ADDENDUM #2

NORTH TRUCKEE DRAIN REALIGNMENT PHASE 1

BID #13/14-007 – PWP# WA-2014-011

This addendum is to notify all potential proposers of clarifications made to the Bid documents as stated below.

SHEET NO. **C-5**

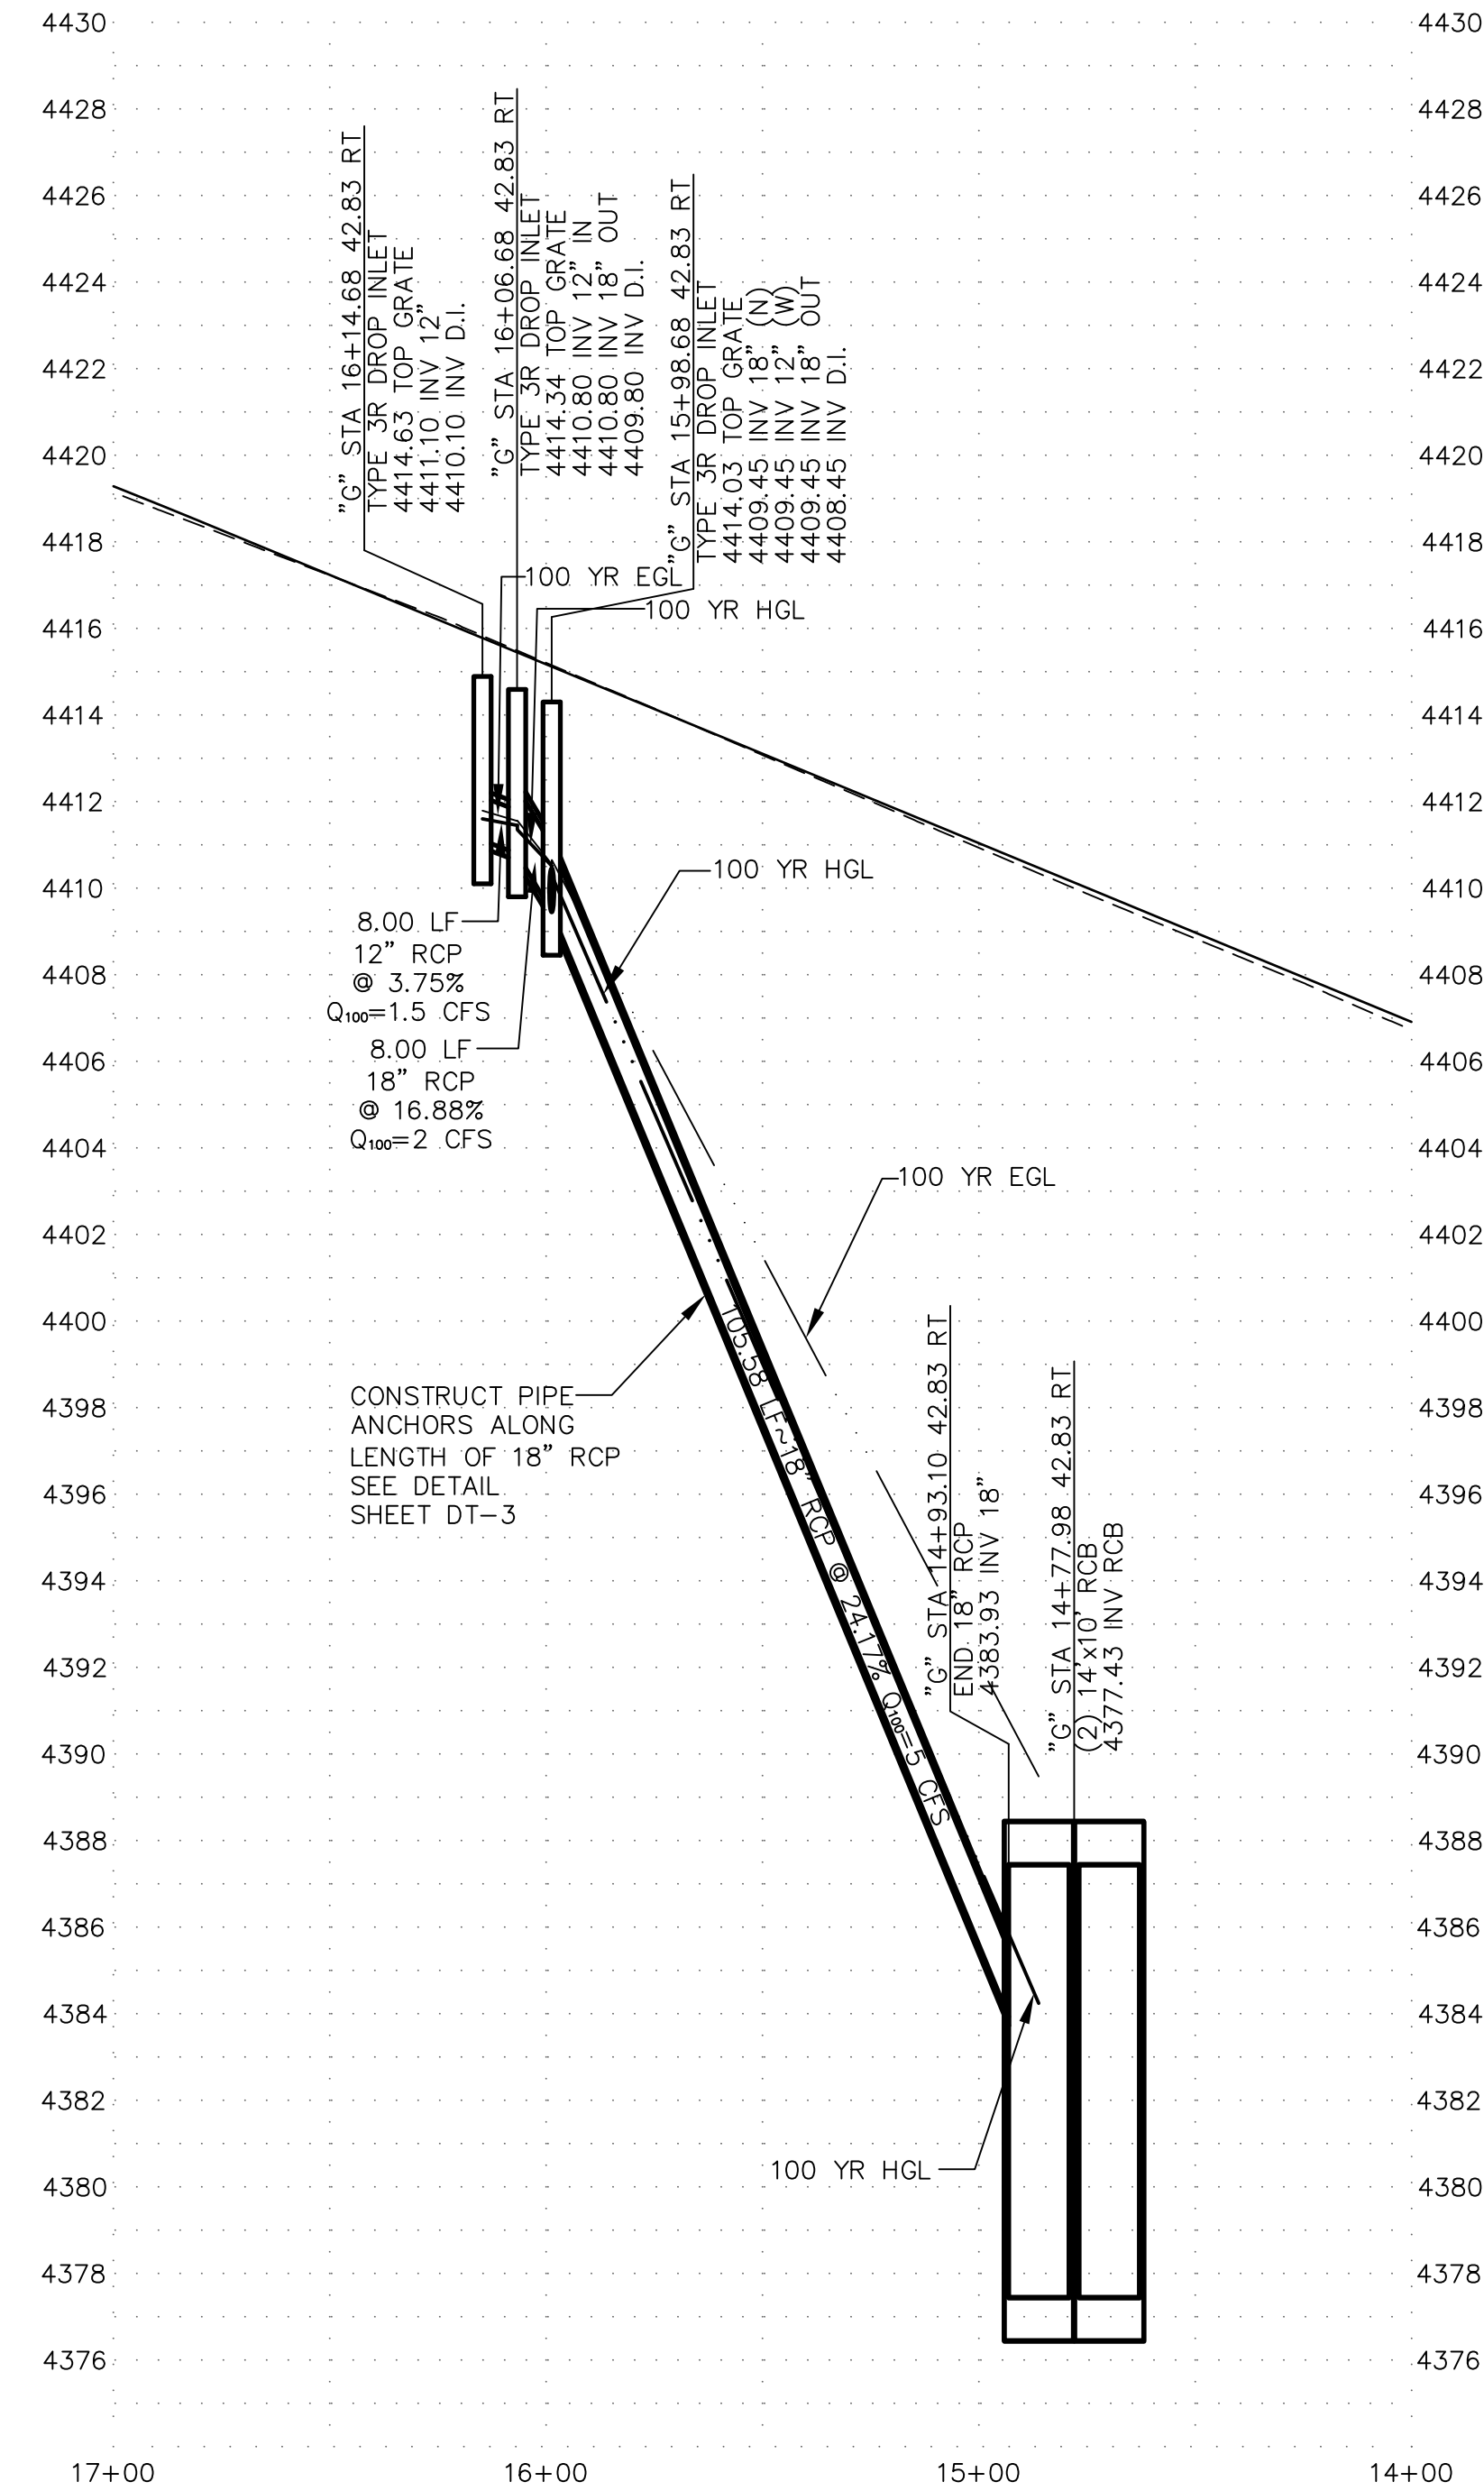
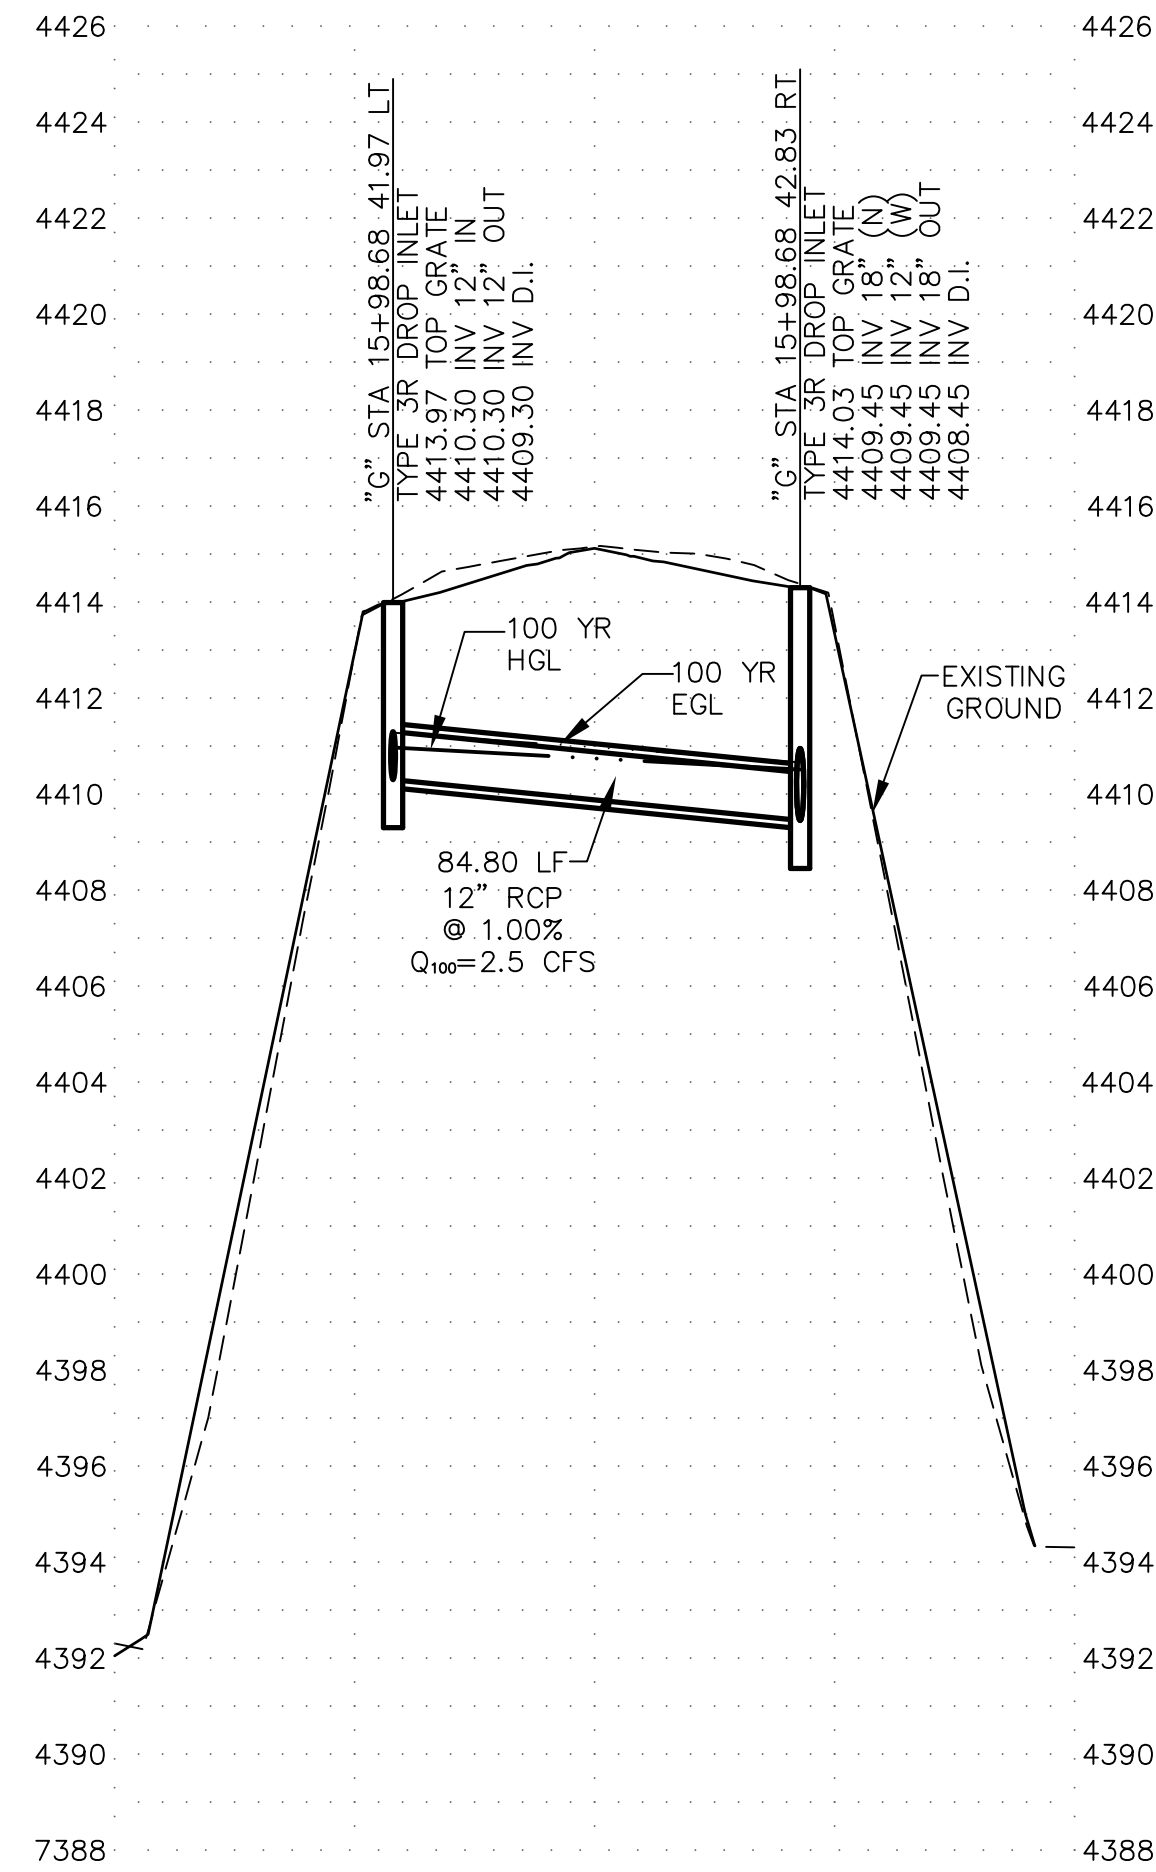
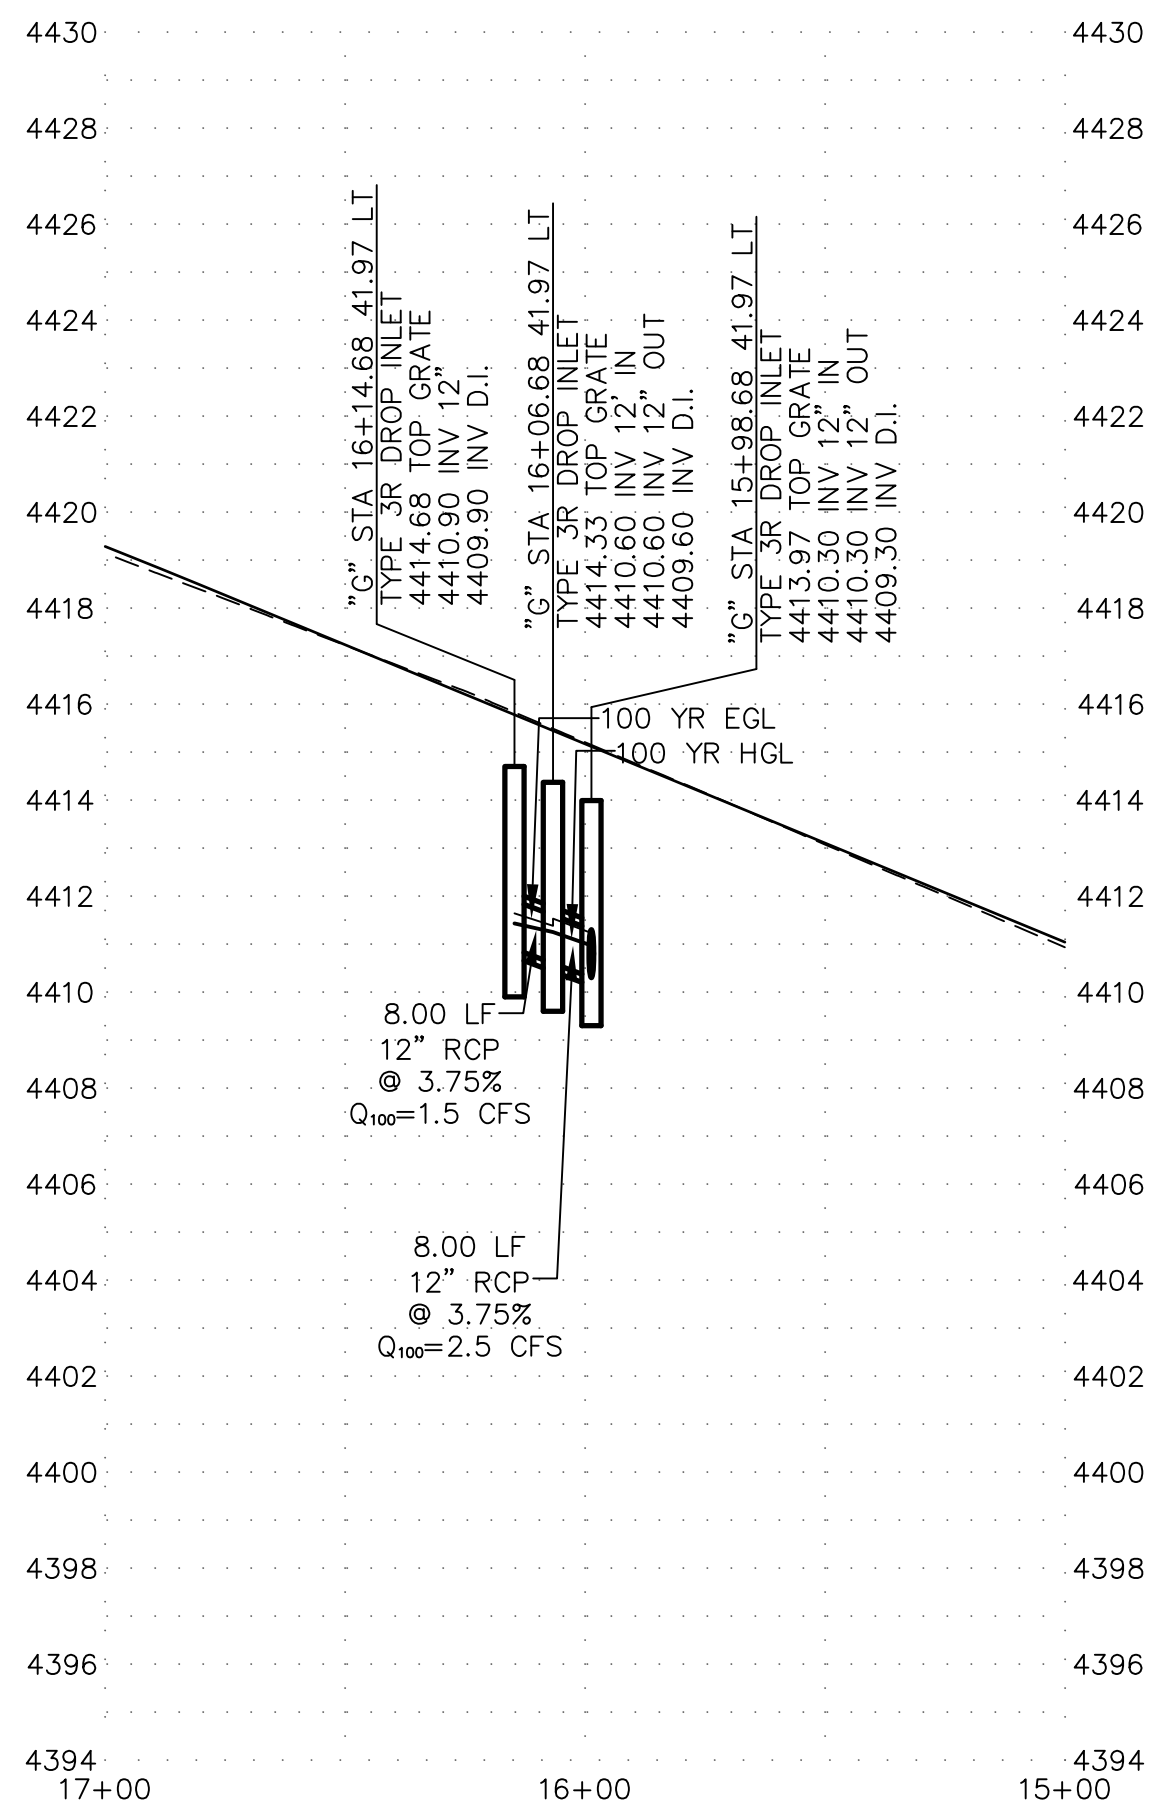
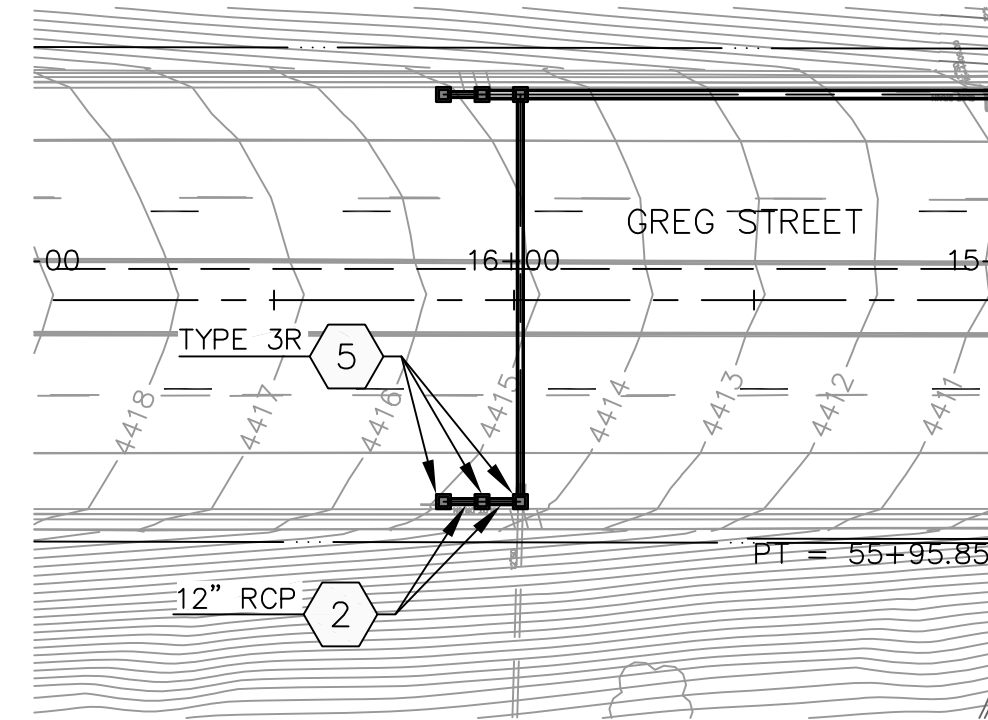
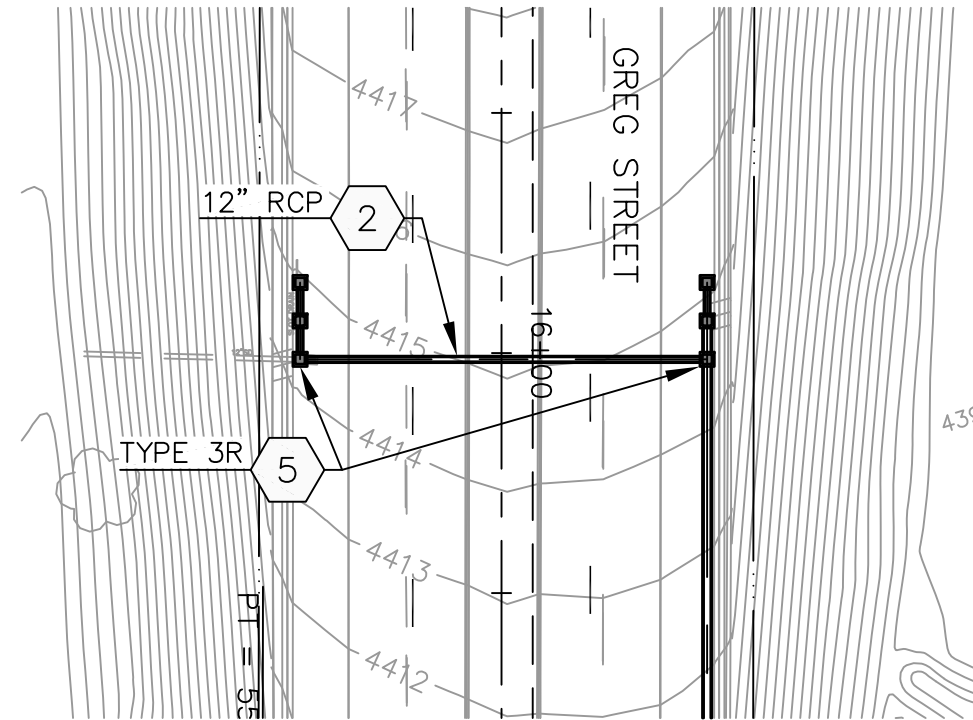
- c. "G" 10+97.47 104.98' RT was changed to "G" 10+98.84 127.81' RT
 - d. "G" 10+47.79 112.79' RT was changed to "G" 10+49.93 127.73' RT
6. Sheet C-5 – Top of grate elevations for drop inlets updated throughout the sheet.
